APPLICATION NO.	FILING DATE	FIRST NAMED INVENTOR	ATTORNEY DOCKET NO.	CONFIRMATION NO.
10/758,802	01/15/2004	Dae-Woong Kang	8750-042	6500
20575 7590 04/20/2007 MARGER JOHNSON & MCCOLLOM, P.C. 210 SW MORRISON STREET, SUITE 400 PORTLAND, OR 97204			EXAMINER WARREN, MATTHEW E	
			ART UNIT 2815	PAPER NUMBER
			MAIL DATE 04/20/2007	DELIVERY MODE PAPER

<b>Advisory Action</b> <b>Before the Filing of an Appeal Brief</b>	<b>Application No.</b> 10/758,802	<b>Applicant(s)</b> KANG ET AL.	
	<b>Examiner</b> Matthew E. Warren	<b>Art Unit</b> 2815

FIG. 14

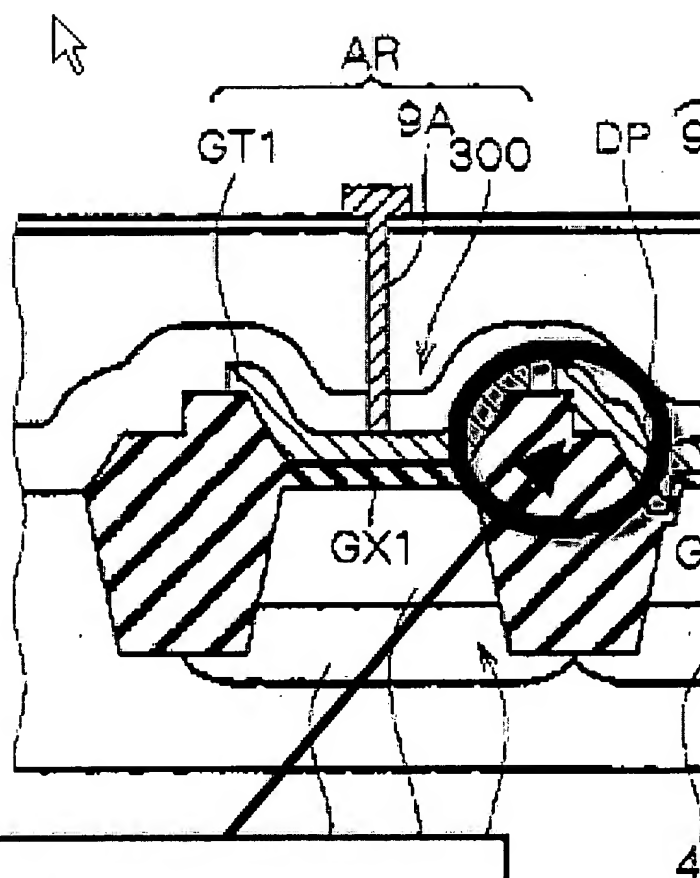
Continuation of 11. does NOT place the application in condition for allowance because: the applicant's arguments are not persuasive. The applicant primarily asserts that Furuta does not show all of the elements of the claims including the limitation of the corner region being spaced laterally away from a vertical axis passing through an upper edge corner of the channel implant region. The examiner still believes that Furuta shows all of the elements of the claims including the limitation in question. The applicant assumes that the corner region in question illustrated in fig. 14 of Furuta is the one that faces the channel implant region. However, as shown in the attached drawing of fig. 14 of Furuta, the corner region interpreted by the examiner faces away from the channel implant region. The corner region of Furuta is definitely spaced laterally away from the vertical axis passing through an upper edge corner of the channel implant region since it is formed above the second, thicker gate oxide layer (GX1) and in the middle of the isolation region (2). This corner region is still part of what the applicant considers "the first-type step regions." The claims do not require that the step region face towards the channel implant region. Therefore, Furuta shows all of the elements of the claims including the limitations in question and the rejection is proper.

Continuation of 13. Other: See the attached drawing Figure 14 (Furuta, US 6,921,947) with the examiner's comments/highlights.

Examiner's interpreted  
corner region.
